**TRAFFIC IMPACT ANALYSIS – ADDENDUM #2**

**RESOLUTION COPPER MINE  
SUPERIOR, ARIZONA**

**19 AUGUST 2020**

## TRAFFIC IMPACT ANALYSIS - ADDENDUM #2 RESOLUTION COPPER MINE PROJECT SUPERIOR, ARIZONA

**RESOLUTION COPPER**  
 GENERAL ARRANGEMENT WITH  
 POST LAND EXCHANGE SURFACE MANAGEMENT  
 Figure 1

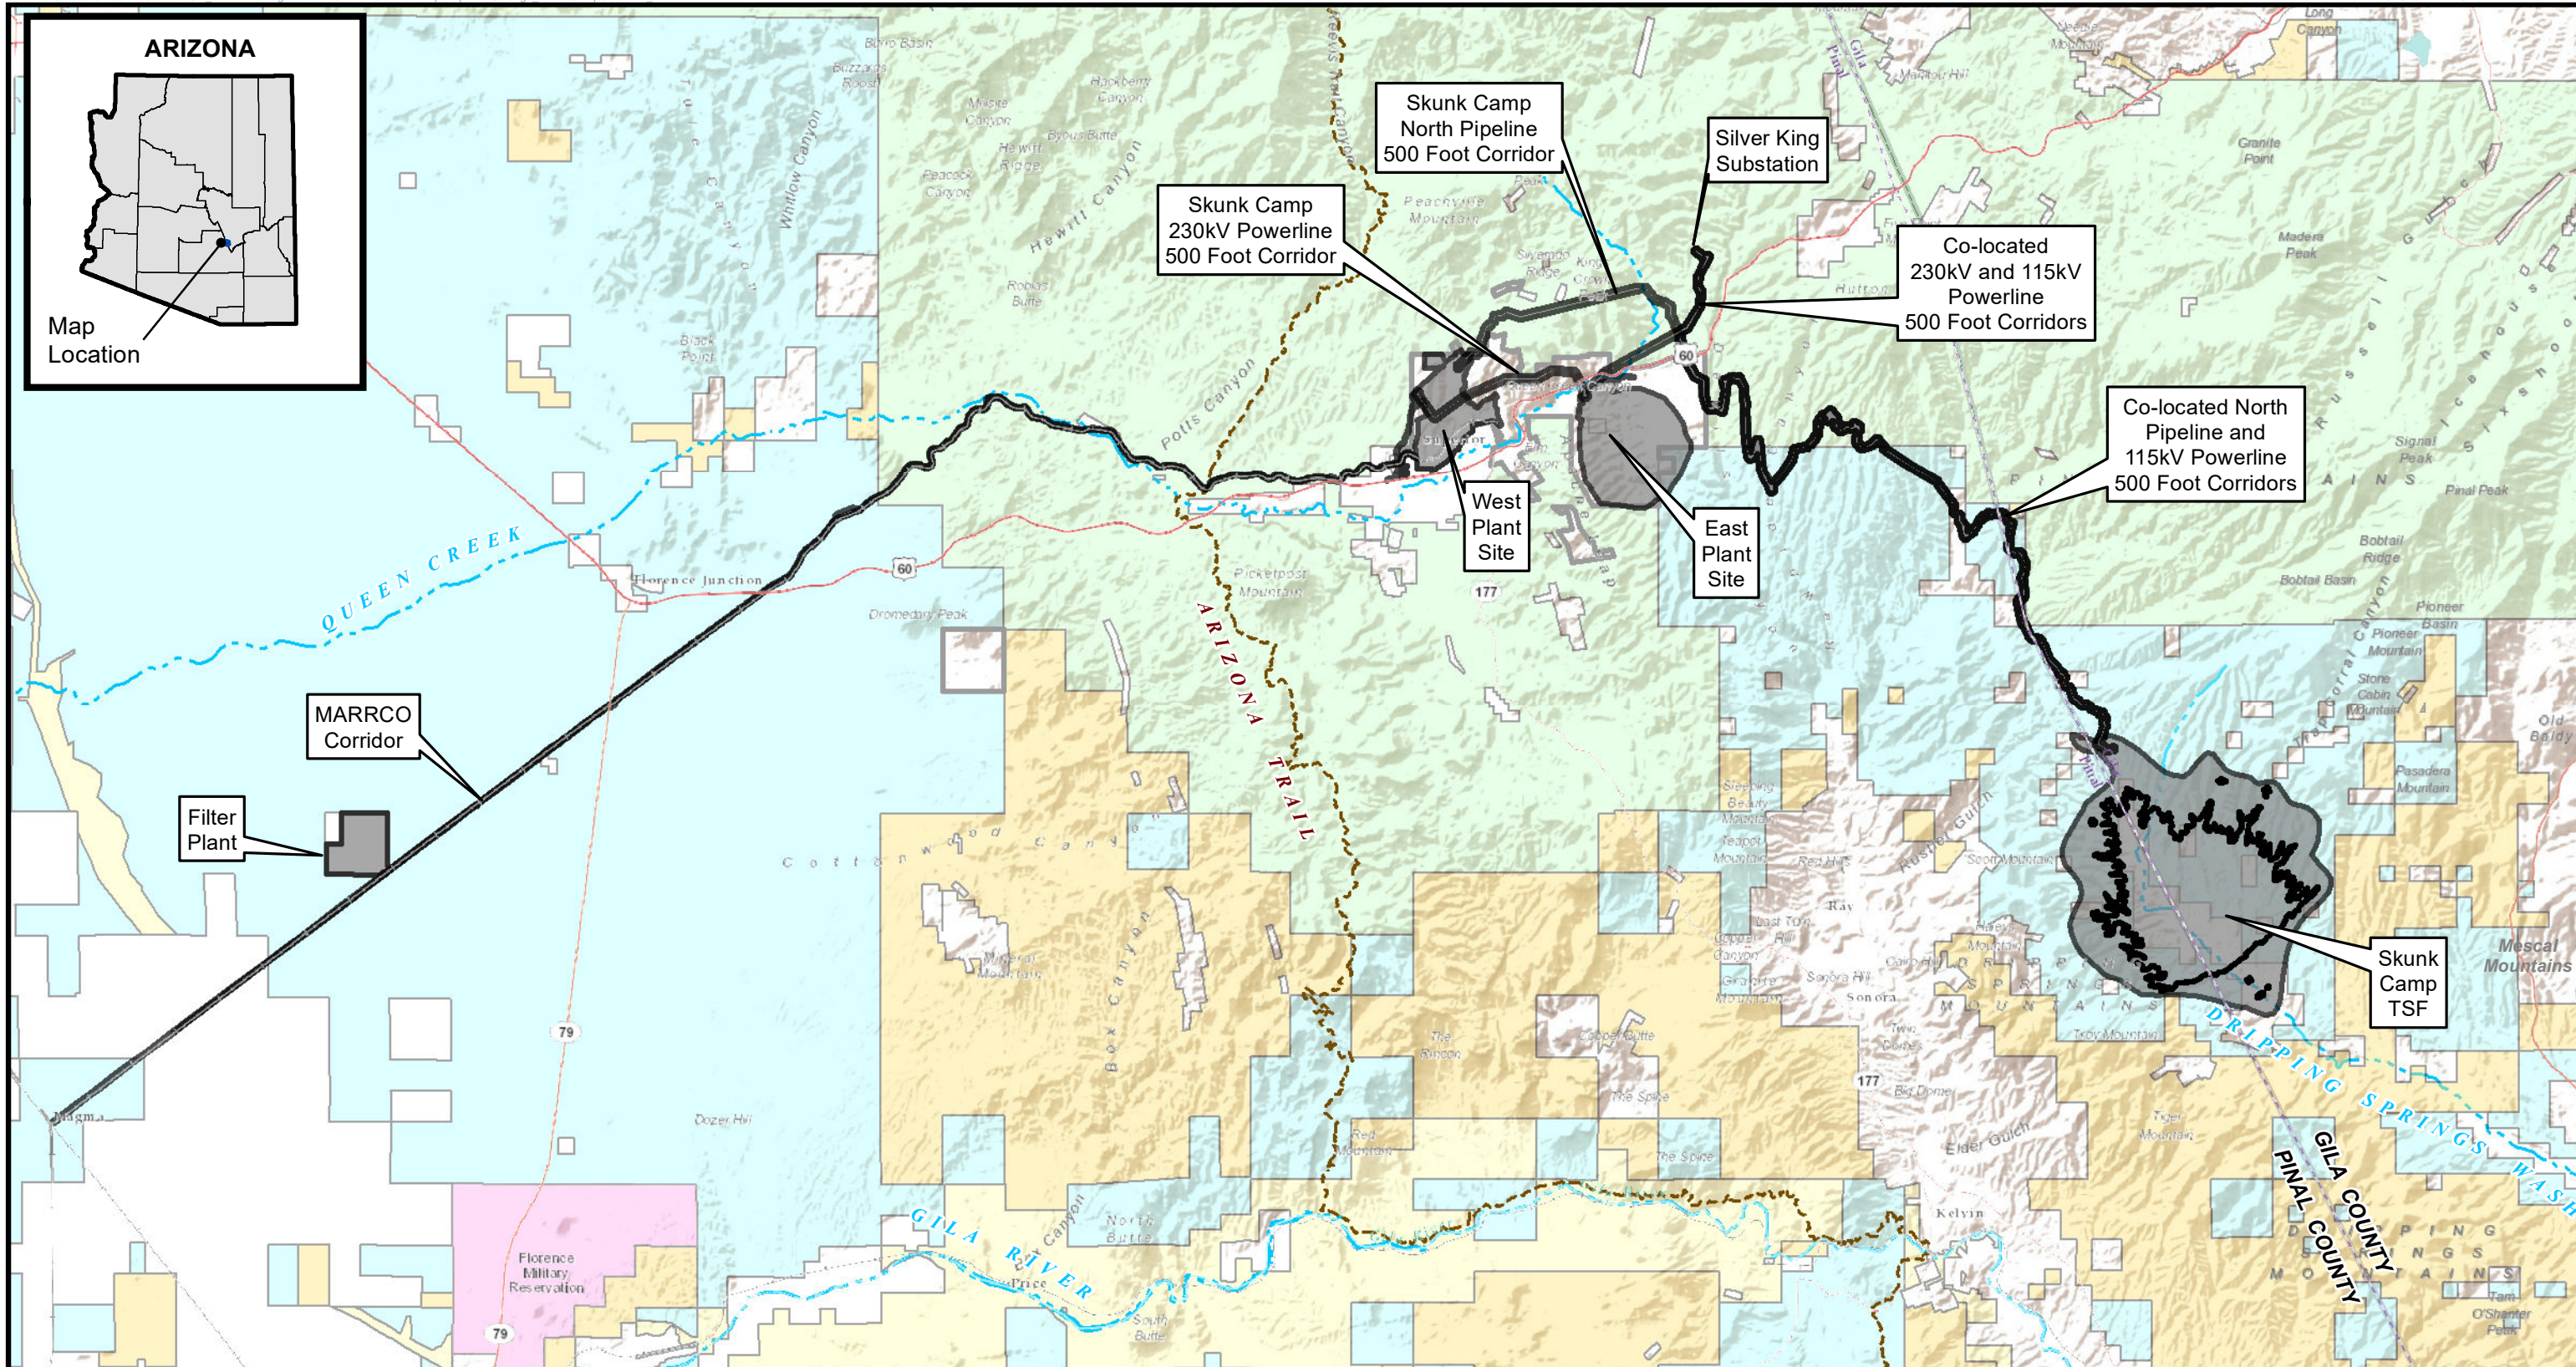
The Draft EIS focused the quantitative traffic analysis solely on the intersections. Based on public comments received, we request that a number of highway segments between intersections also be analyzed for directional impacts. The following segments should be included:

- U.S. 60 between the Phoenix/Mesa metropolitan area and Superior
- State Route 79 between Florence and U.S. 60
- U.S. 60 between Superior and Globe
- State Route 177 between Superior and Winkelman
- State Route 77 between Winkelman and Globe

The trips expected to be generated by the mine expansion are insignificant from a regional and freeway capacity perspective. The greatest number of trips expected to be generated by the mine expansion during peak construction or operations (approximately 1,600 daily trips) are in line with any relatively small 'strip-mall', shopping center or gas station: developments that are routinely analyzed and discussed with no expectation of statewide, regional freeway implications. For context, a 10-pump gas station and convenience store would be expected to generate approximately 2,300 daily trips (43% more than the peak mine construction traffic).

To illustrate this point, an analysis of six roadway segments was completed:

- (2) locations on US-60 between the Phoenix/Mesa metropolitan area and Superior
- (1) location on SR-79 between Florence and US-60
- (1) location on US-60 and between Superior and Globe
- (1) location on SR-177 between Superior and Winkelman
- (1) location on SR-77 between Winkelman and Globe

This segment analysis is shown in **Figure 2**. **Figure 2** shows:
